SUBJECT: ISSUANCE OF AMENDMENT NO. 116 TO FACILITY OPERATING LICENSE NPF-9 AND
AMENDMENT NO. 98 TO FACILITY OPERATING LICENSE NPF-17 - MCGUIRE
NUCLEAR STATION, UNITS 1 AND 2 (TACS 77558/77559)

Document Name: MCGUIRE AMEND REDUCE COOLANT

SAFETY EVALUATION BY THE OFFICE OF NUCLEAR REACTOR REGULATION
RELATED TO AMENDMENT NO. 116 TO FACILITY OPERATING LICENSE NPF-9
AND AMENDMENT NO. 98 TO FACILITY OPERATING LICENSE NPF-17
DUKE POWER COMPANY
DOCKET NOS. 50-369 AND 50-370
MCGUIRE NUCLEAR STATION, UNITS 1 AND 2

FIGURE 2.1-1

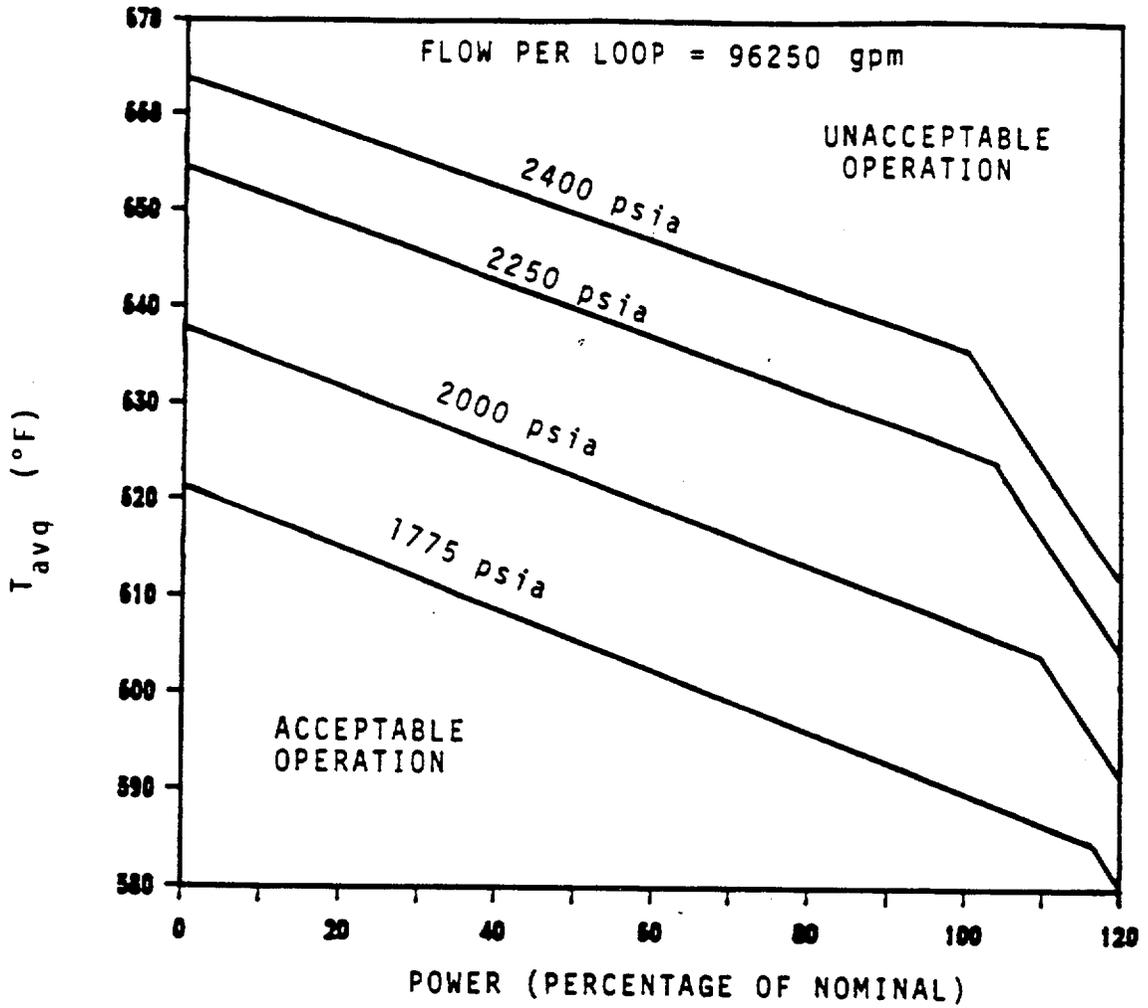
In its September 4, 1990 submittal, the licensee evaluated the impact of operation at one percent reduction in minimum measured flow on thermal margin. The reduced flow rate resulted in a slight reduction in core departure from nucleate boiling (DNB) limits. Consequently, the licensee developed revised core safety limits for average RCS temperature as a function of power for the reduced flow rate. These revised limits are identified in a proposed TS Table 2.1-1, "Reactor Core Safety Limit - Four Loops In Operation." The flow per loop identified on proposed Figure 2.1-1 is 96250 GPM, which is the minimum measured flow (MMF) rather than the thermal design flow (TDF). The MMF differs from the TDF by an amount equal to instrument uncertainty. For consistency, the terminology in TS Table 2.2-1 is changed from "design flow" to "minimum measured flow" when the loop flow of 96250 GPM is identified. These changes are acceptable.
